Our Case Number: ABP-316272-23

Re: Bus Connects Templeogue/Rathfarnham to City Centre Core Bus Corridor Scheme
Templeogue/Rathfarnham to City Centre

**BusConnects Templeogue / Rathfarnham to City Centre CBC
Objection to proposed Compulsory Purchase Order - 12 Rathfarnham Wood,
Rathfarnham, Dublin 14 - Plot List: 1020(1).1d, 1020(2).2d
Submission on Planning Application in respect of and Proposed CPO of
Woodland area of Rathfarnham Castle Park – Plot List: 1001(1).1f; 1002(1).1f and 1001(2).2f;
1002(2).2f**

**BusConnects Dublin Templeogue / Rathfarnham to City Centre CBC
Submission on Planning Application in relation to the Proposed Scheme
Objection to proposed Compulsory Purchase Orders
Rathfarnham Castle Park
Entrance to Rathfarnham Wood Estate**

Close up view of Fig 13.1 – Surfacewater study area – showing no watercourse marked beside RCP although it is an open watercourse just inside the RCP wall where it will be directly built over. This is despite the fact that the maps at Fig 14.5 and Fig 14.13 clearly show the Glin River and duck pond.

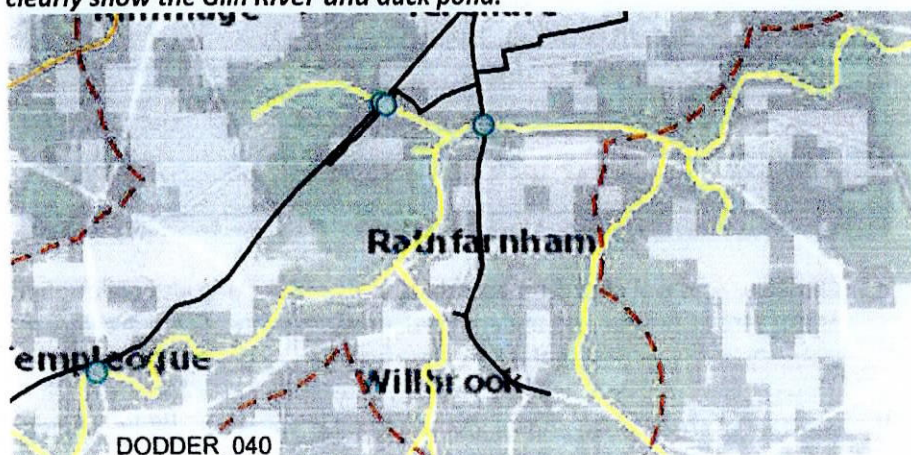
Yet when it comes to the actual environmental study areas, the Glin River and duck pond are not included. They have clearly not been evaluated or even considered. We cannot understand this glaring omission and clear breach of the Water Framework Directive.

Image 2.14 from Chapter 2 of the EIAR showing minimal impact from Grange Road to Rathfarnham Road / Fergus Road:

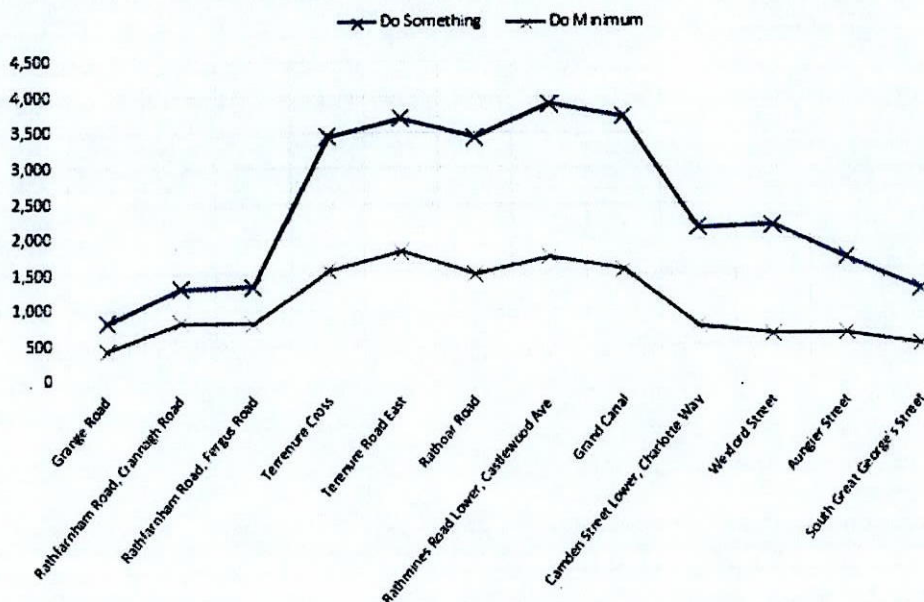
The projections show that the proposed reductions in journey time due to BusConnects will be minimal. Image 2.14 in Chapter 2 of the EIAR shows that the BusConnects scheme would have a far lesser impact around Rathfarnham than it would at other areas in any event.

Fig 12.1.3. - Ecological Study Areas: Aquatic and Riparian Survey Site:

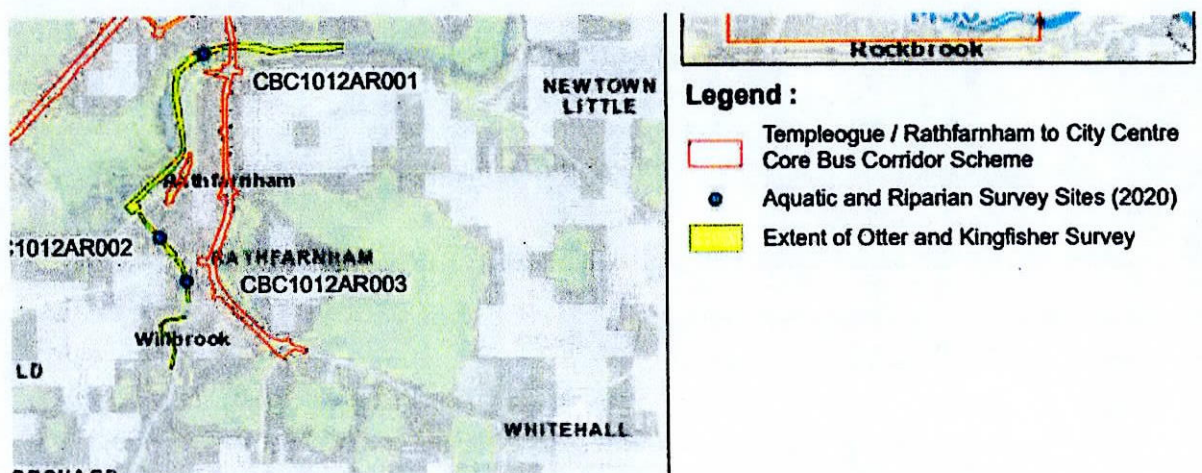
It is clear that neither the Glin River nor the pond were surveyed for otters or kingfishers. This is despite the fact that a kingfisher has been spotted in the Park, most recently on 23/7/23 and the Glin River / Whitechurch Stream is a known otter habitat.

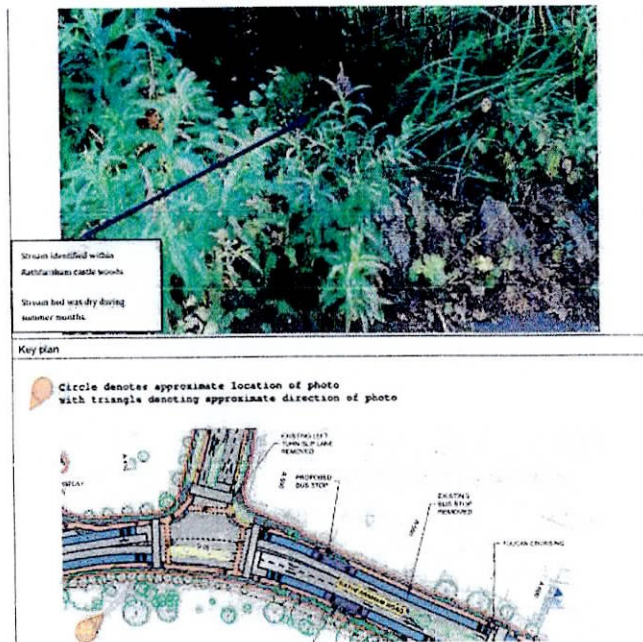
However it can be seen from the above table that the only stream in RCP identified in this survey was thought to be running “adjacent to the proposed bus corridor”, not actually under the corridor at two locations. See below indicator from Image 07 of where the photo was taken, close to Butterfield Avenue:

Image 07 in Appendix 14.1 notes the presence of an apparently “dry” stream close to Butterfield Avenue (it is an active watercourse) yet completely fails to consider that there is a pond in the Park and a water source, the River Glin, constantly feeding and draining that pond!

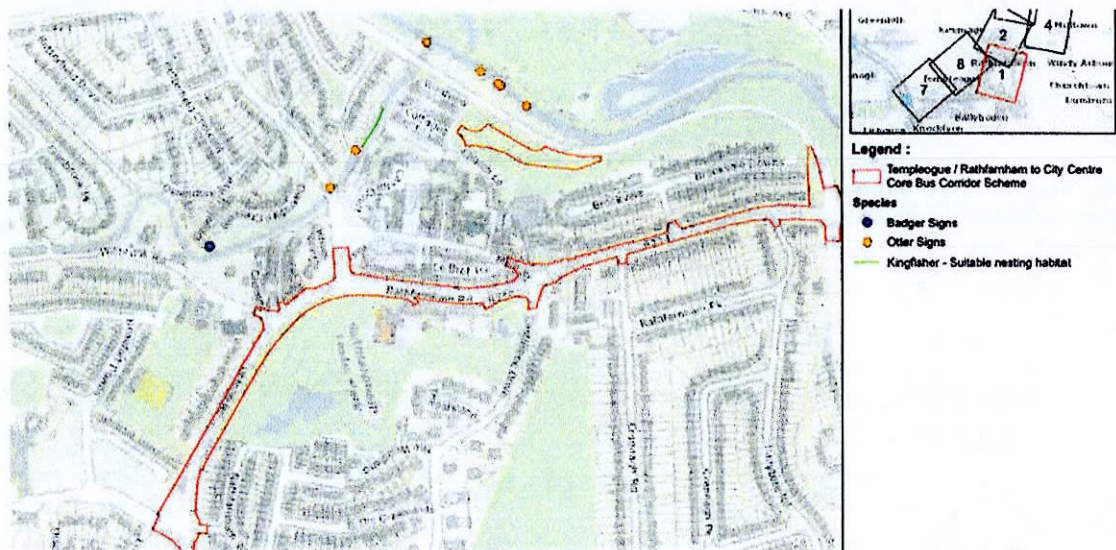
- *No evidence of amphibians or reptiles; [there are plenty of frogs in RCP, as can be seen from the photo above so we cannot understand this] and*
- *A total of 75 breeding bird species and 30 species with breeding and wintering bird populations [again, note the photos of the grey heron and black headed gull – Rathfarnham Castle Park has simply not been reviewed from this perspective; there are very many wild birds in the Park, including the two current families of tufted ducklings and numerous mallards].*

Fig 12.9 - Mammal, Aquatic and Riparian Survey Results - Note that otter and badger signs were found in the nearby area, yet RCP, a particularly important wildlife habitat with an active watercourse and a pond rich in aquatic life, wasn't even surveyed. Note also that RCP was not surveyed as a suitable kingfisher nesting habitat, although a kingfisher has been seen very recently:

Vol 1 – General Arrangement Drawings (pg. 6) – all trees marked in green, regardless of whether they are to be retained or not – highly misleading:

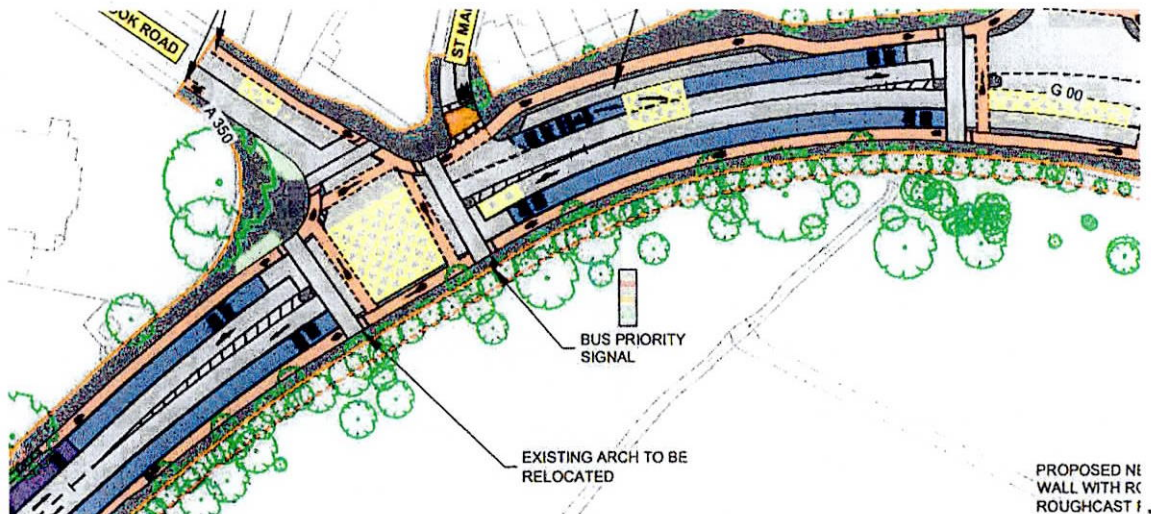
The same approach is taken in many of the maps (e.g. Vol 1 – General Arrangement Drawings), which mark all trees in green, regardless of whether they will need to be removed or not, making it very difficult to ascertain from this document exactly how many mature trees will be lost. This is contrary to the usual approach of clearly marking in red which individual trees will be lost.
